Ordinary Council Meeting - 17 June 2024

PS ref: 6771

**SAT APPEAL – BYFORD MIXED COMMERCIAL CENTRE - RESPONSE TO s31 CONDITIONS  
 LOT 806 SOUTH WESTERN HIGHWAY, BYFORD**

Lot 806 South Western Highway, Byford  
Austroads 2013: 19m Semi Trailer  
Through movements at roundabout

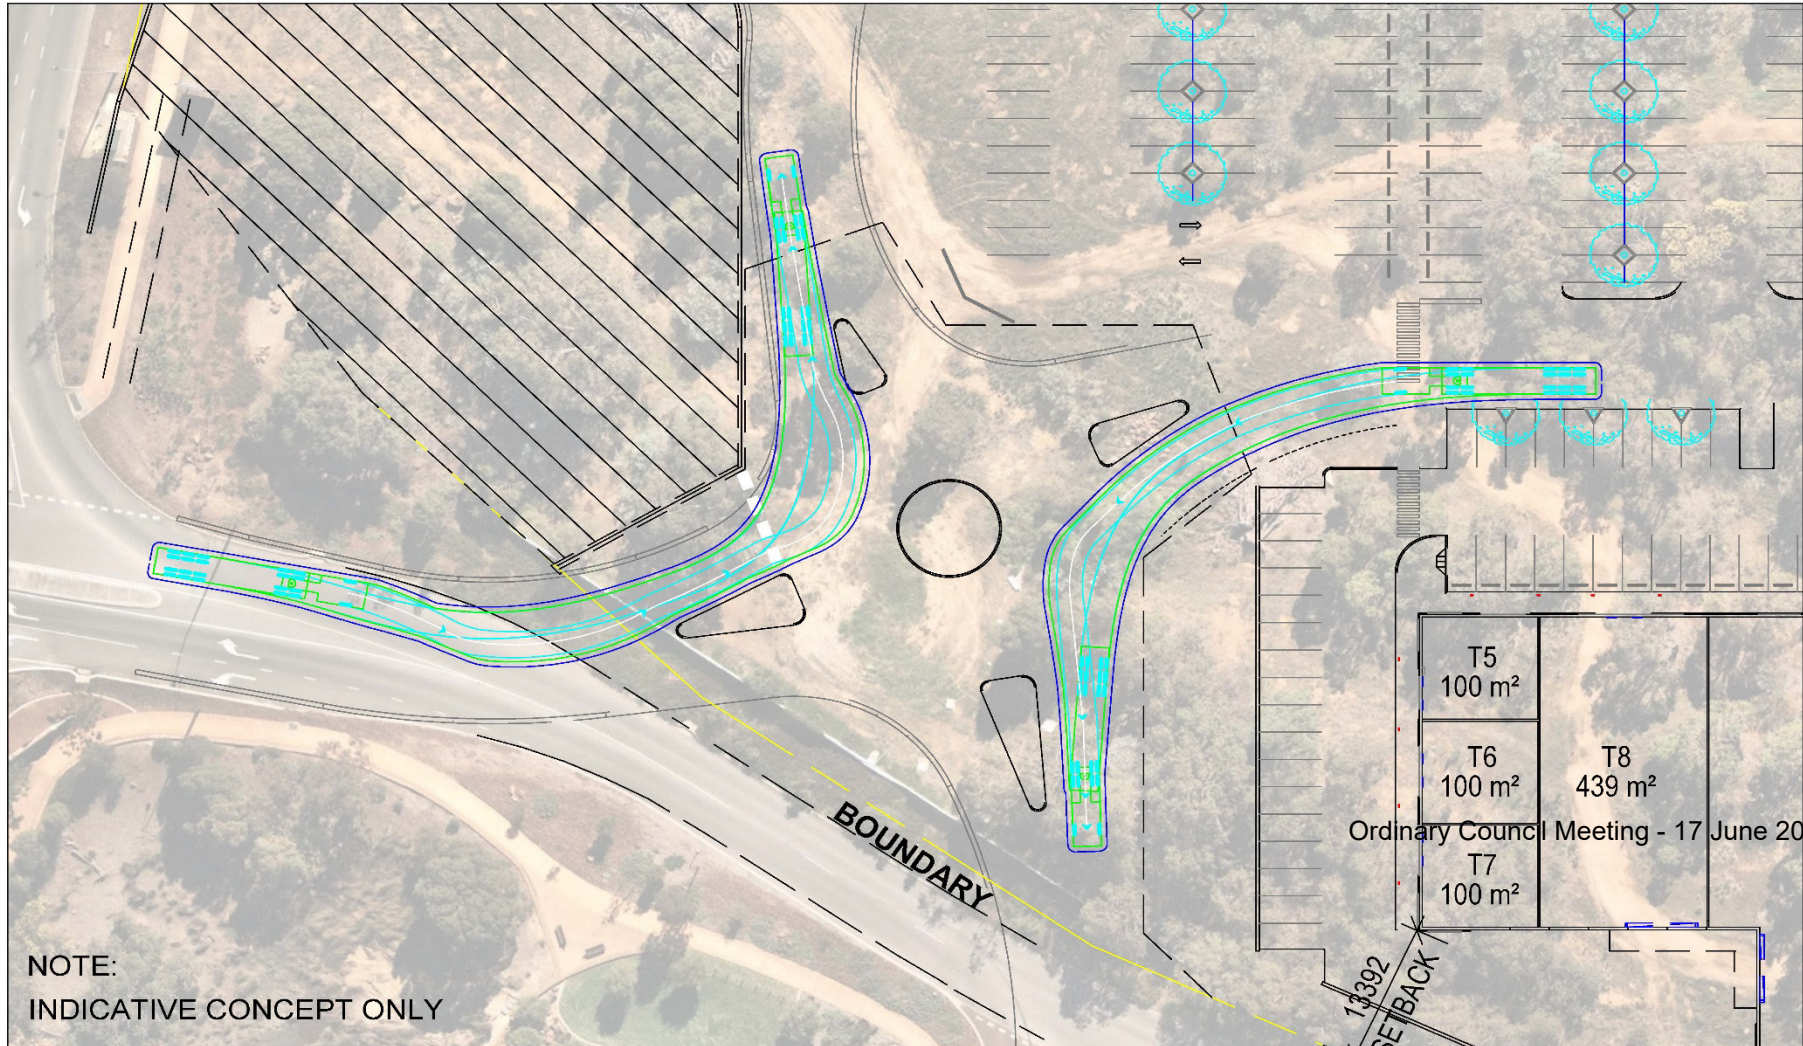
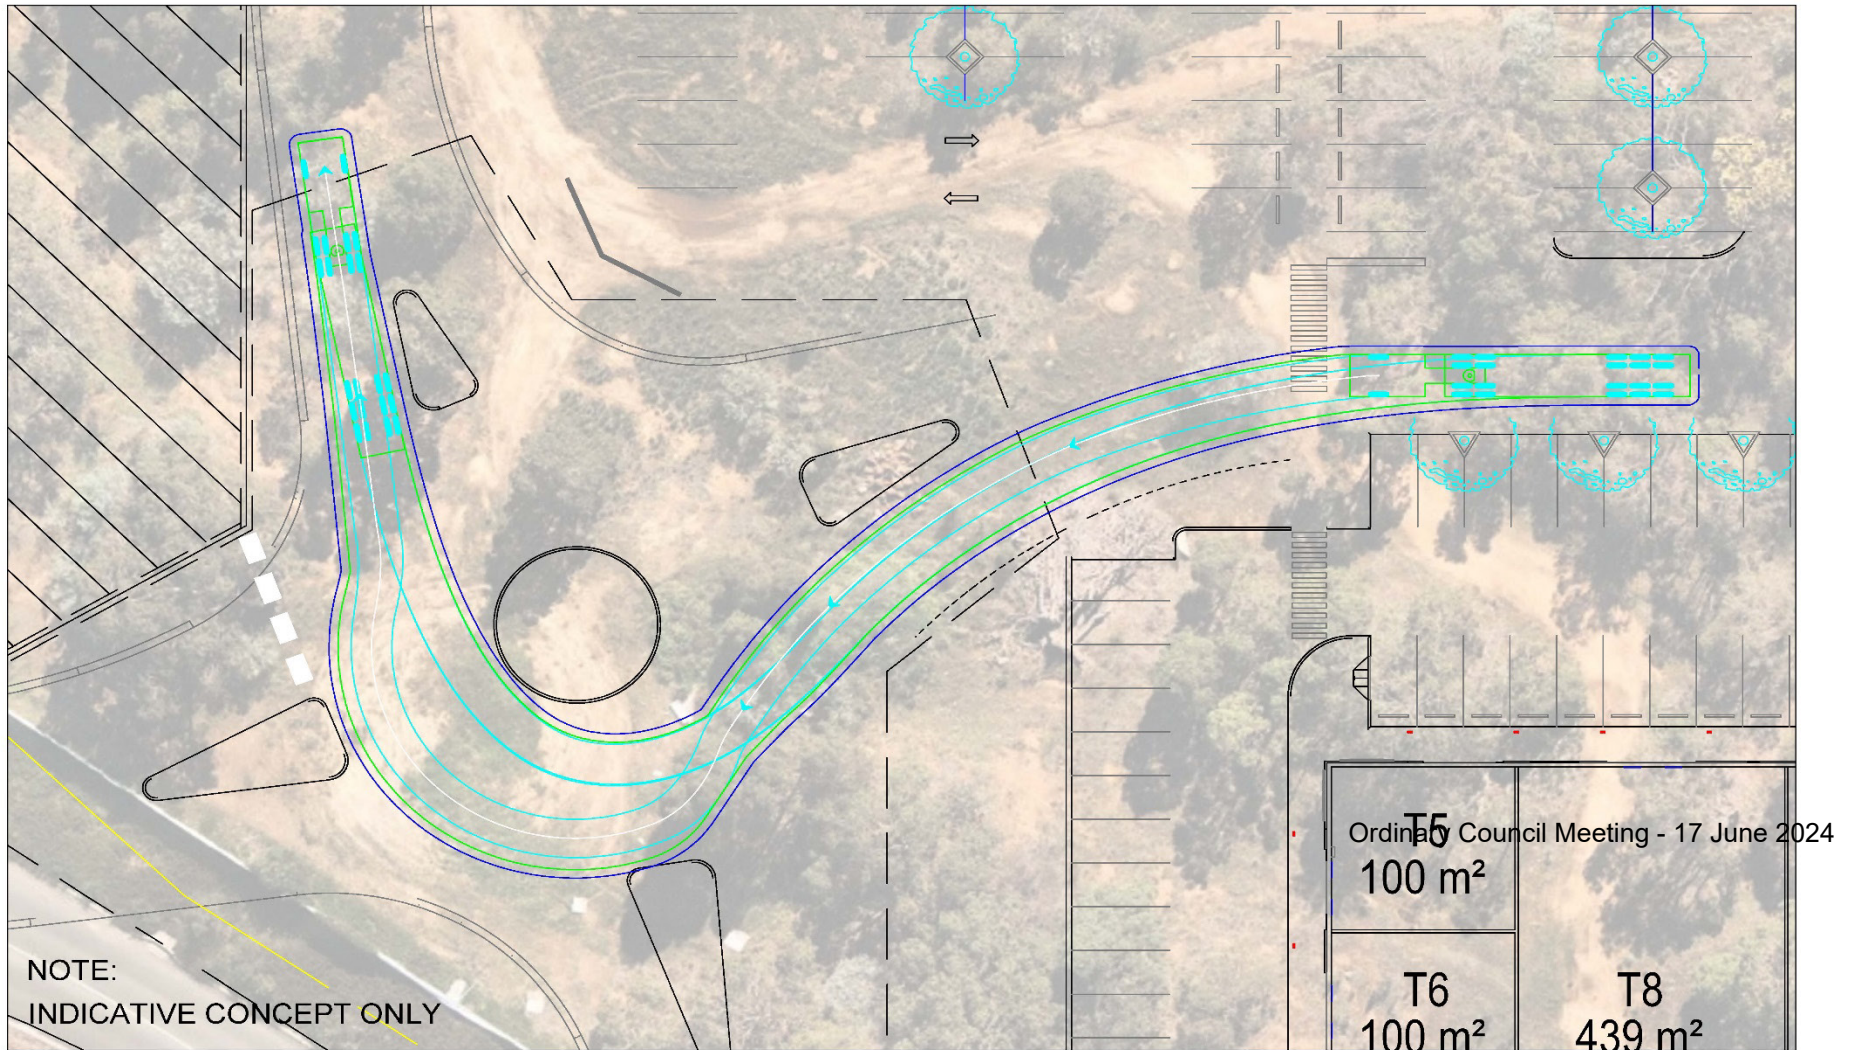
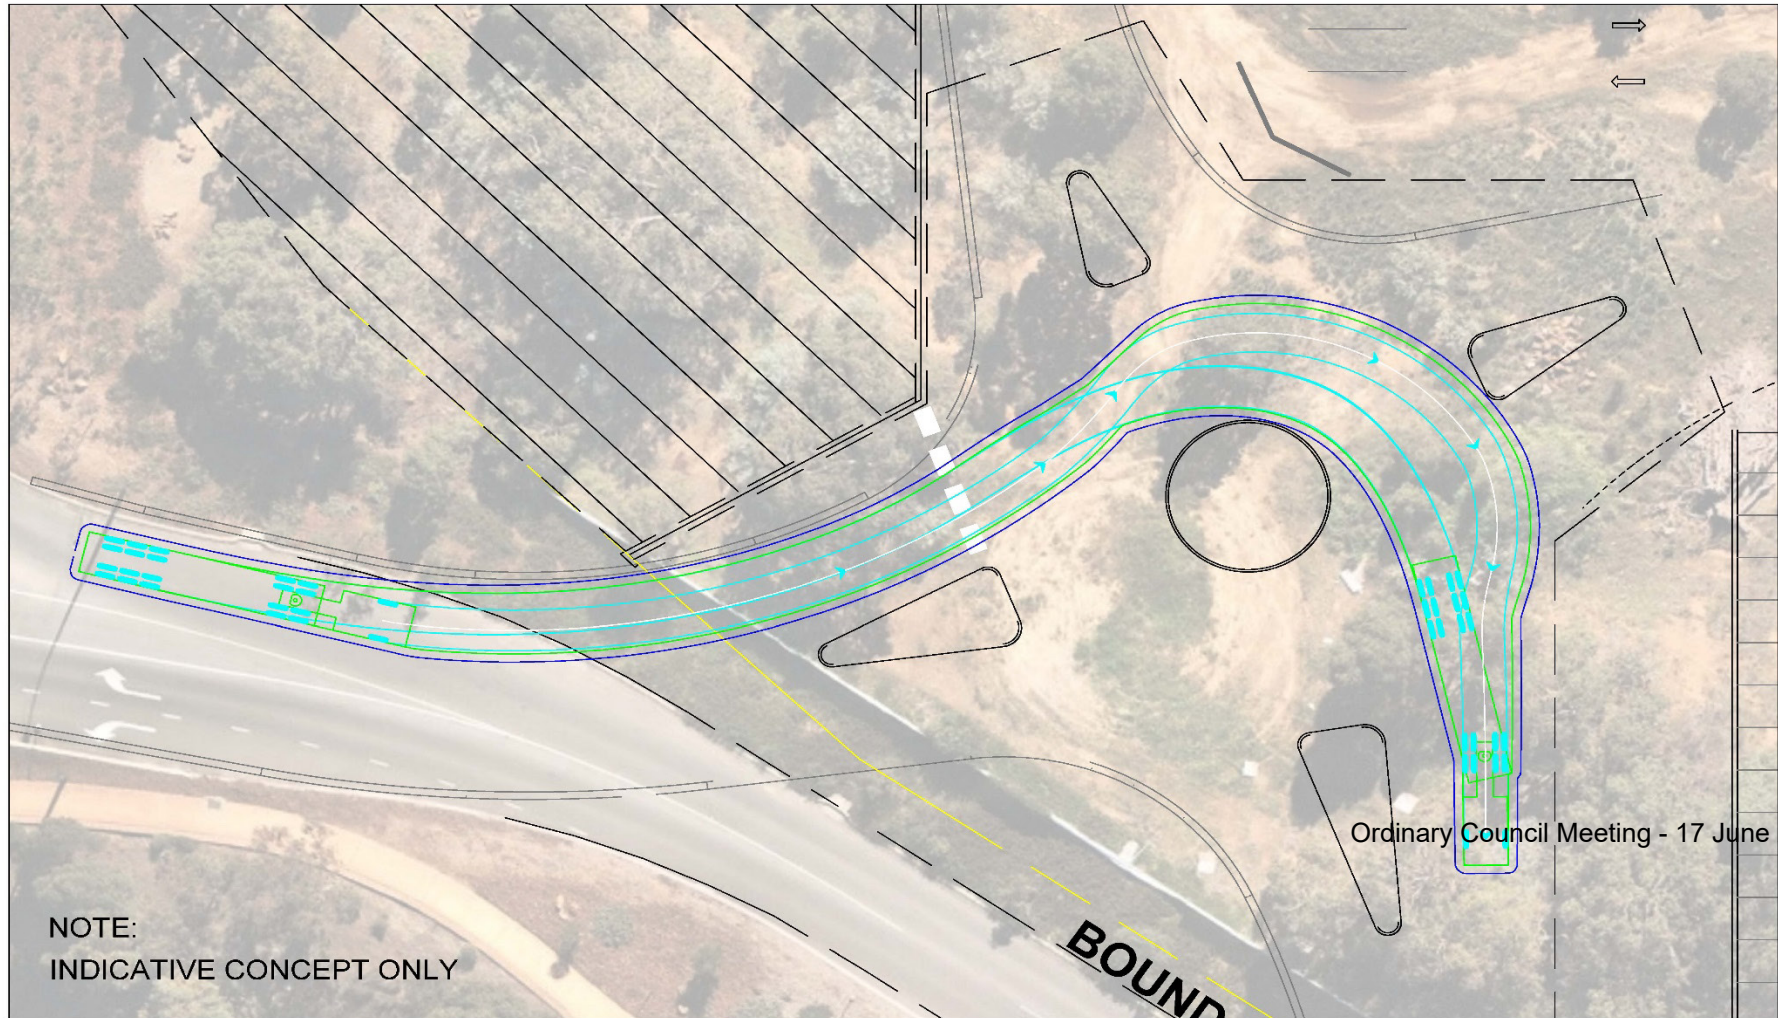
Following the second mediation meeting, an additional transport technical note and swept path plans were prepared confirming that the design of the approved internal roundabout **currently accommodates** a 19m semi-trailer. Refer **Attachment 4**. Accordingly, as the matters of the condition have now been suitably addressed, Condition 1p is redundant and is respectfully requested to be **deleted**.

The results of the turn path analysis indicate that the proposed roundabout can accommodate the movements of the 19m semi-trailer satisfactorily. This implies that sufficient space is available to design a suitable roundabout to facilitate the movements of vehicles up to a 19m semi-trailer.

The findings of the turn path analysis provide assurance that a satisfactory roundabout can be designed at the proposed location to effectively accommodate the turning requirements of the Design Vehicle which in this case is a 19m semi-trailer (as-of-right vehicle).
